ADDENDUM NUMBER THREE (3)
TO
TOWN OF FRANKLIN
WASTEWATER SYSTEM IMPROVEMENTS

This Addendum Number Three (3) is issued this the 5th of January 2012 to all parties who hold a set of Bid Documents for the project entitled: "**Town of Franklin – Wastewater System Improvements**". This Addendum Number Three (3) shall become part of the Contract Documents and its receipt acknowledged on the bid documents at the time of bidding.

HEADWORKS / FLOW
 EQUALIZATION SITE
 IMPROVEMENTS PLAN
 FENCING REVISIONS

ADDENDUM
 No. 3
C-109A

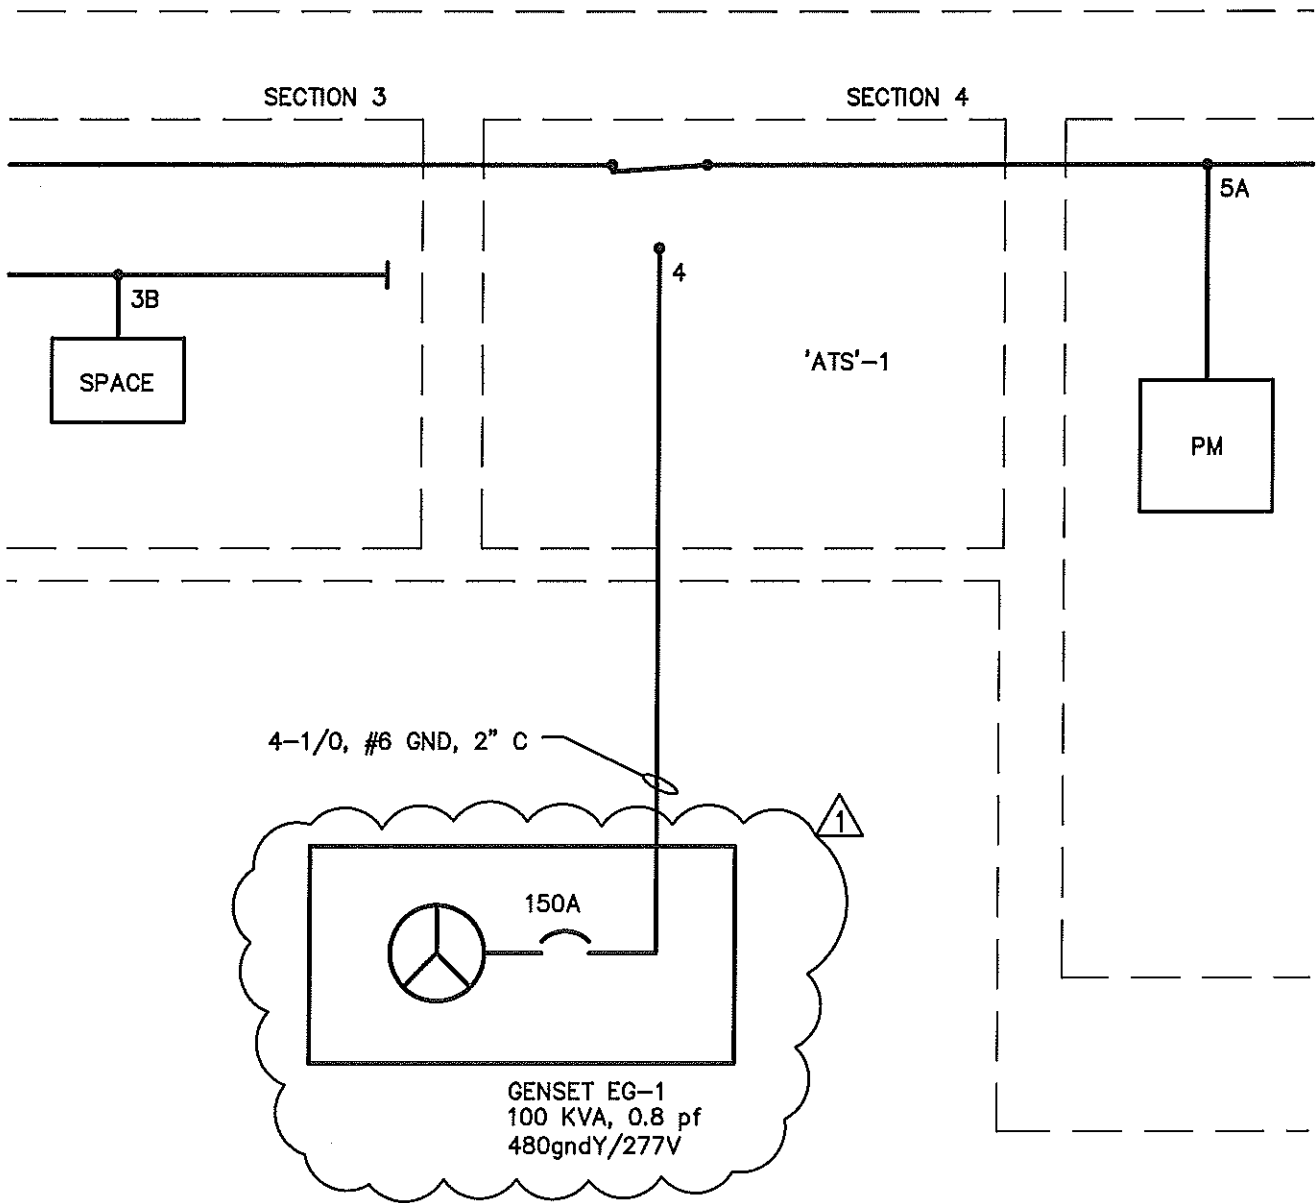
"Note: All exposed concrete surfaces inside wetwell above elevation 1984.50' shall receive two coats of approved epoxy coating suitable for exposure to sewer gas. Coating shall be Tnemec Series 66 Hi-Build Epoxoline at 4.0-6.0 mils dry film thickness per coat or equivalent coating as provided by Glidden, Carboline or approved equal. Surface preparation shall be per manufacturer's recommendation."
- B. Sheet C-109: The attached C-109A (8.5"x11") drawing illustrates the revised chain link fence alignment. The chain link fence alignment has been revised to allow the proposed 18' cantilever slide gate and automatic electric operator to be installed inside the fence line. Please note the revised fence alignment and update project plan sheets C-108, C-109, C-113, C-114, E-101, and E-102 accordingly.

NOTE:
 CHAIN LINK FENCE ALIGNMENT REVISED TO
 ALLOW 18' CANTILEVER SLIDE GATE WITH
 AUTOMATIC ELECTRIC OPERATOR TO BE
 INSTALLED INSIDE THE FENCE LINE.

PROPOSED
 6' CHAIN LINK FENCE WITH
 18' CANTILEVER SLIDE GATE
 WITH AUTOMATIC ELECTRIC
 OPERATOR. OPEN TOWARDS
 PUBLIC WORKS BUILDING.
